**LAND USE APPLICATION SUMMARY**

*Property Location:* 823 15<sup>th</sup> Avenue SE  
*Project Name:* 823, LLC  
*Prepared By:* Kimberly Holien, Senior Planner, (612) 673-2402  
*Applicant:* Craig Janssen, Elmwood Properties  
*Project Contact:* Craig Janssen, Elmwood Properties  
*Request:* To construct a new residential building with ten dwelling units.  
*Required Applications:*

<b>Variance</b>	To reduce the minimum lot area requirement in the R4 district from 1,250 square feet of lot area per dwelling unit to 901.6 square feet of lot area per dwelling unit.
<b>Site Plan Review</b>	For a new 10-unit residential structure.

1 NORTH ELEVATION  
 Scale: 1/8" = 1'-0"

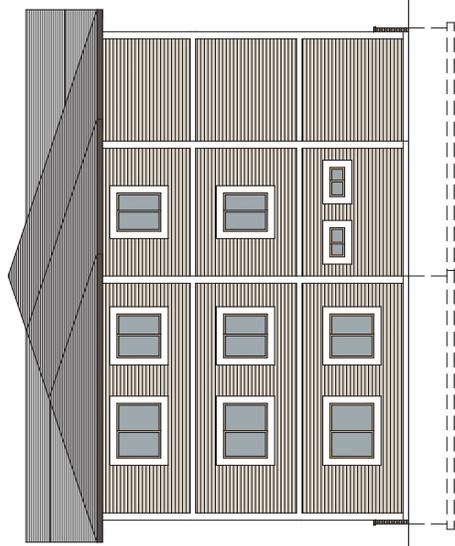
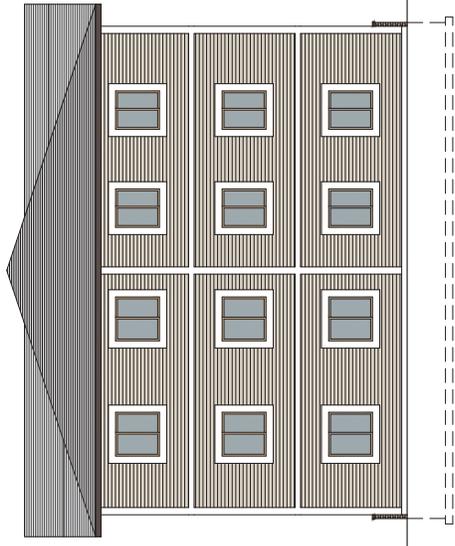
- The applicant is proposing LP Smart Siding as the building’s primary exterior material. The front and rear elevations will have brick at the base. Each elevation requires alternative compliance for the City’s durability standards for exterior materials (see Table 2). Please note that exterior material changes at a later date may require review by the Planning Commission and an amendment to the site plan review.
- The application is consistent with the City’s policy of allowing no more than three exterior materials per elevation, excluding windows, doors, and foundation materials.
- Plain face concrete block is not proposed along any public streets, sidewalks, or adjacent to a residence or office residence district.
- The exterior materials and appearance of the rear and side walls of the building are similar to and compatible with the front of the building.

- **Exterior materials.** The applicant is seeking alternative compliance to allow LP Smart Siding for more than 30 percent of each elevation. Given the size and scale of the project the proposed exterior material may be appropriate. Further, another iteration of the project received approvals two years ago before the material percentages were put into practice. That previously approved building included a similar siding material. As such, staff recommends granting alternative compliance.

1 EAST ELEVATION  
 Scale: 1/8" = 1'-0"

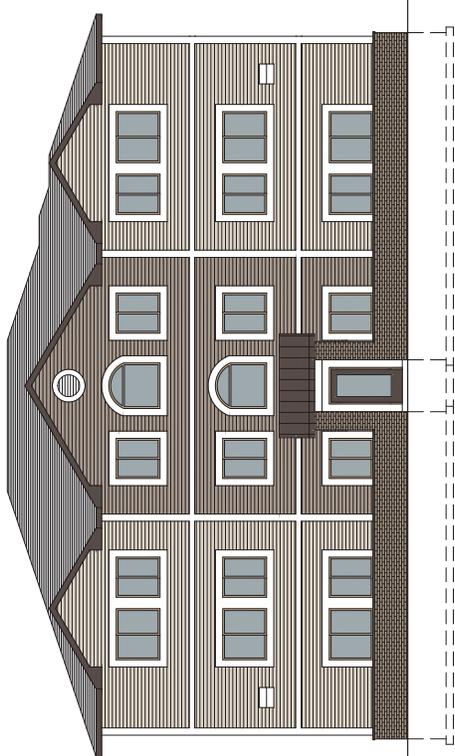
- **Windows.** The Alternative compliance is requested for the minimum window requirements on the east and west elevations. For residential uses, at least twenty (20) percent of the walls on the first floor and ten (10) percent of the walls on each floor above the first that face a public street, public sidewalk, public pathway, or on-site parking lot, shall be windows. On the east elevation, facing the street, windows are provided for 18.6 percent of the first floor. On the west elevation, facing the parking lot, glazing is only provided for 15.4 percent of the first floor. Alternative compliance is requested. Staff does not recommend granting alternative compliance and additional glazing will be recommended as a condition of approval.

4. east elevation: 1st floor- 20 square feet of additional glazing required
  - Plantings shall be required in the proposed rain gardens, including native grasses, perennials and the like.

2. CPED staff shall review and approve the final site, elevation, landscaping, and lighting plans before building permits may be issued.
3. The first floor of the east and west elevations shall include windows for 20 percent of the elevation, per Section 530.120 of the zoning code.
